October 2017 | Final Environmental Impact Report
State Clearinghouse No. 2016011073

CORONA DEL MAR MIDDLE AND HIGH SCHOOL SPORTS FIELD(S) PROJECT

for Newport-Mesa Unified School District

Figure 1 - 2339 Aralia St - Key Map (Day/Night)

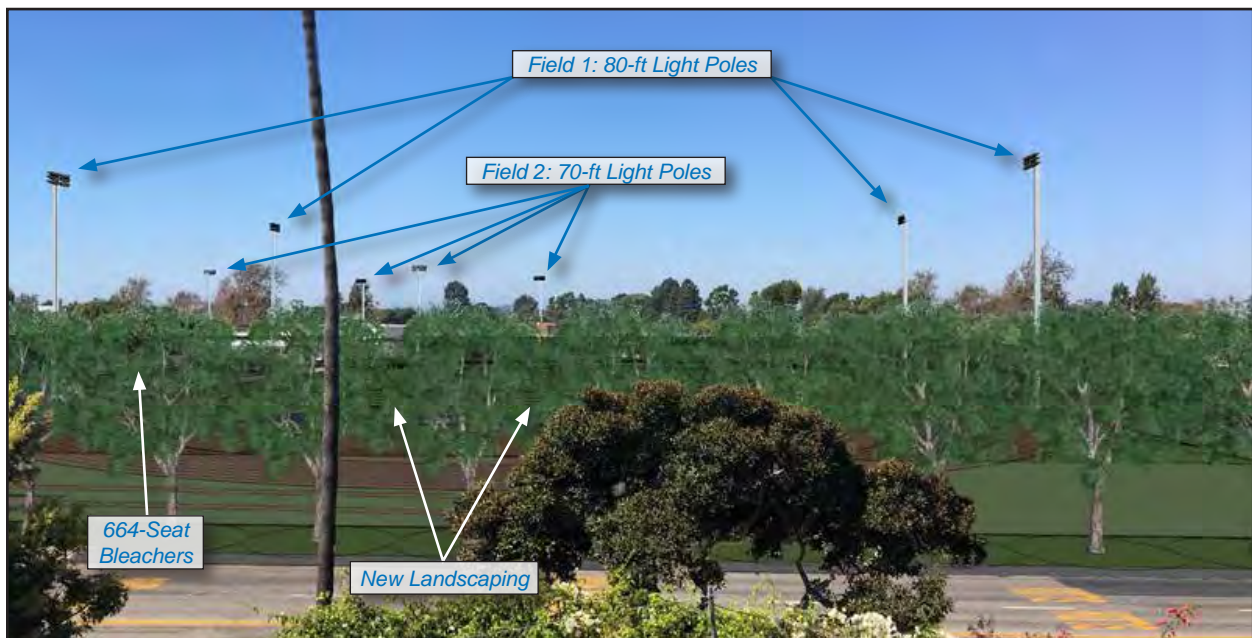
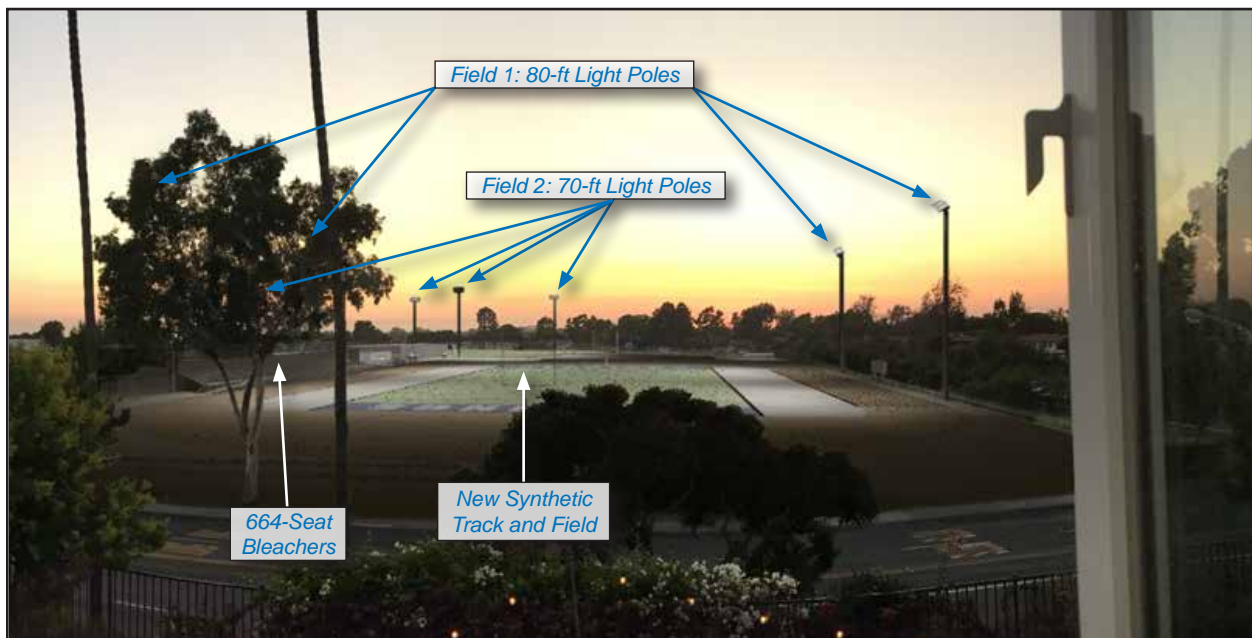
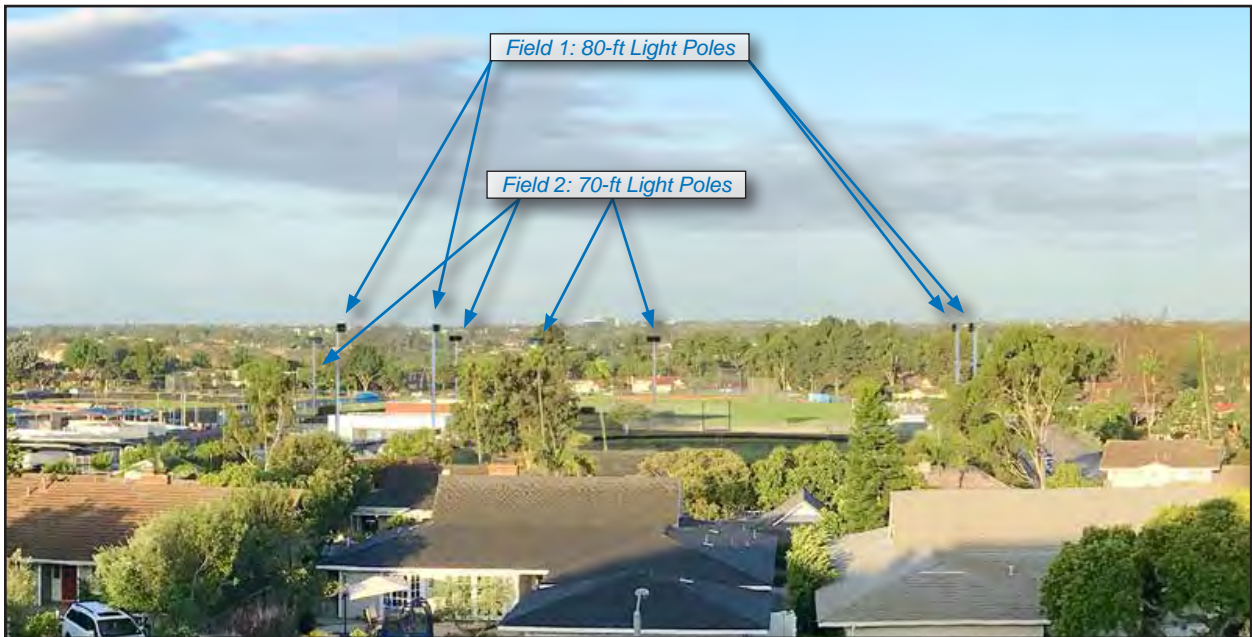
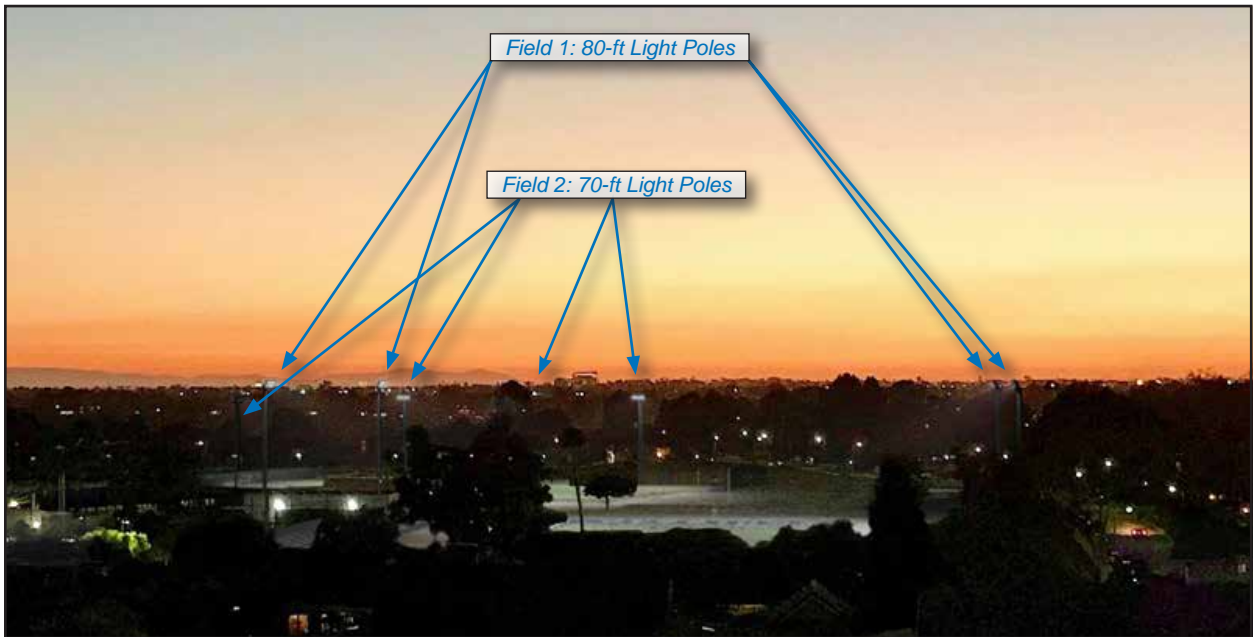
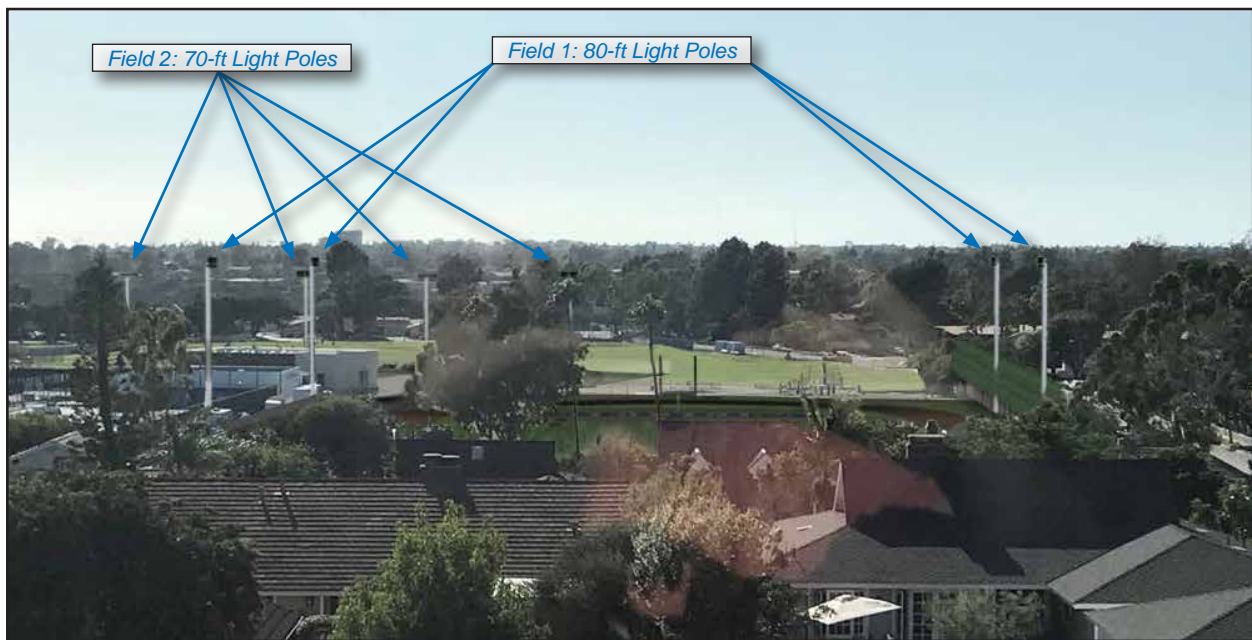
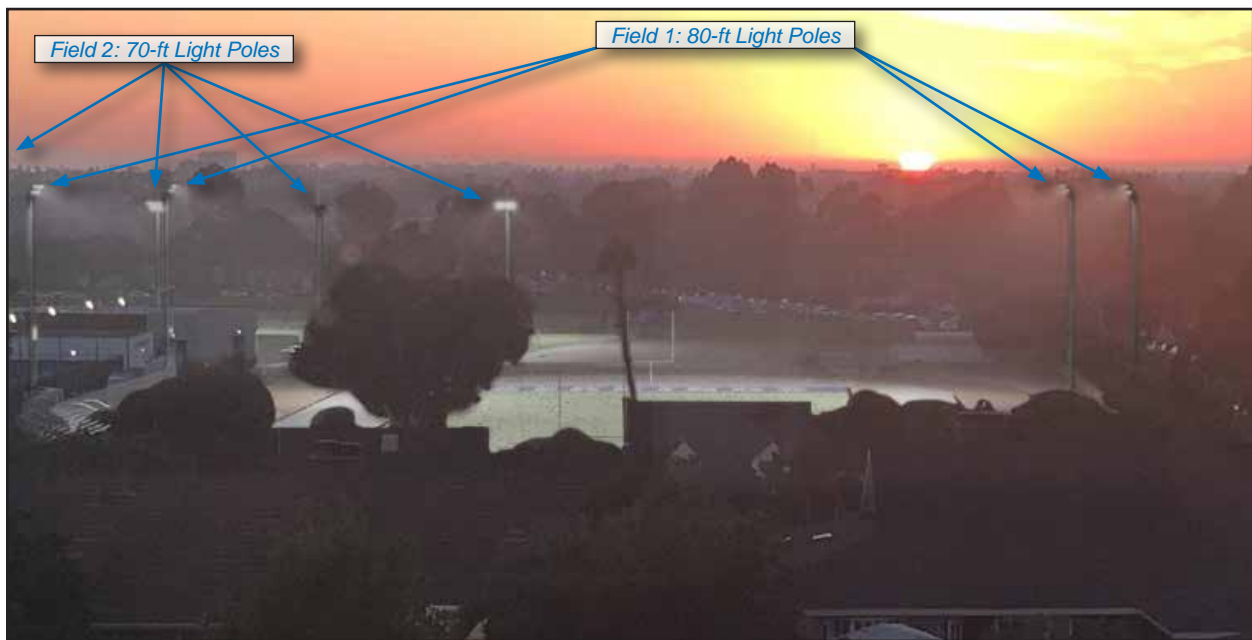
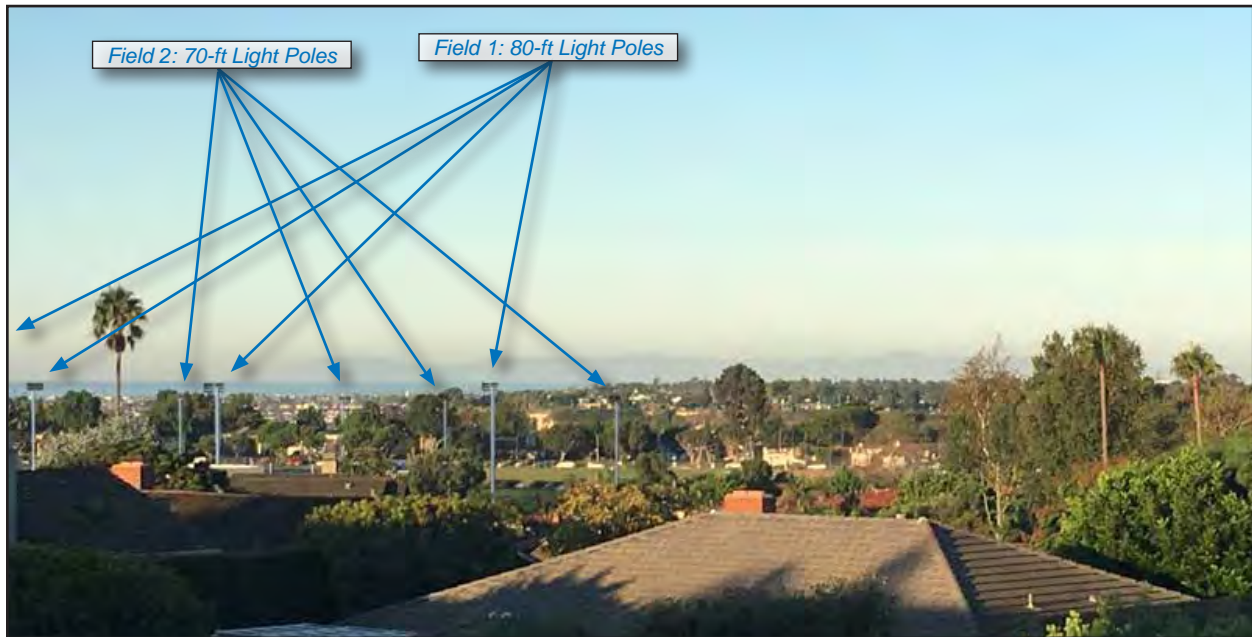
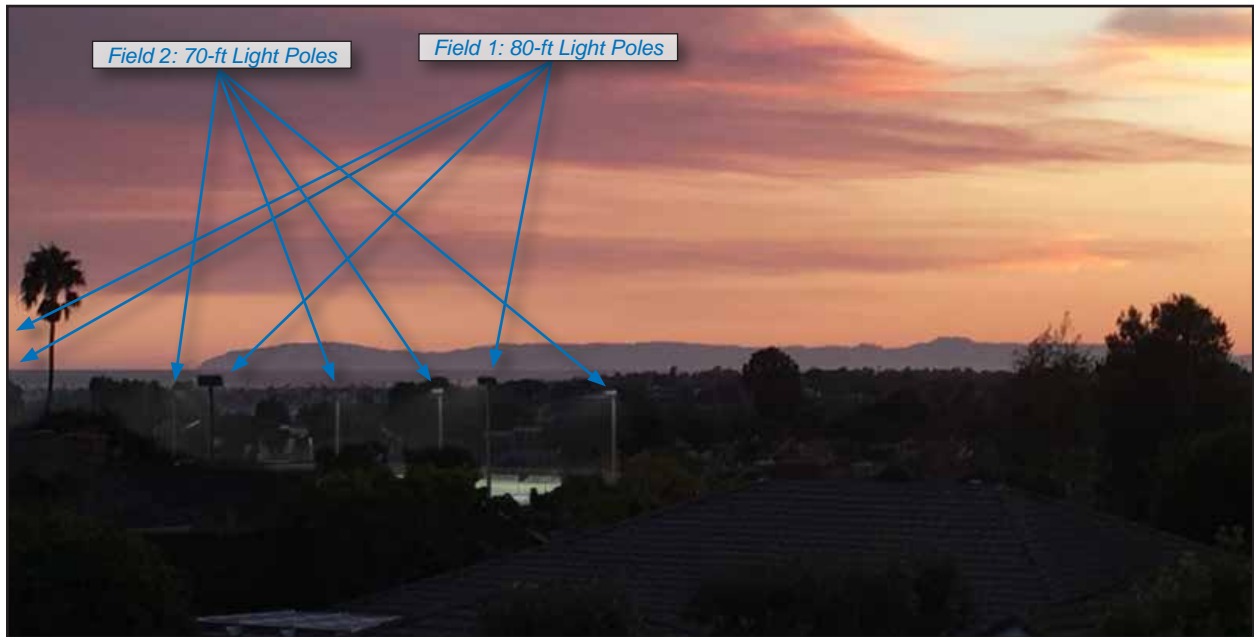
- CC27-1 Please refer to Master Responses 2.1.1.1, *General Opposition* and 2.1.5.1, *Property Values and Quality of Life*.
- CC27-2 Please refer to Master Responses 2.1.2, *Lighting*, including Figure 1 through 12 that show views from various points in Eastbluff community.

- Regardless, additional visual simulations have been added to the FEIR as requested by Eastbluff Association. The Association has provided day and evening photographs from four locations with its community. Visual simulations from these locations have been added in Master Responses 2.1.2.4, *Additional Visual Simulations* (See Figures 1 through 12). These views illustrate similar visual impacts as provided in the RDEIR, thereby demonstrating that the visual and lighting impacts would not be substantially different than the existing conditions.
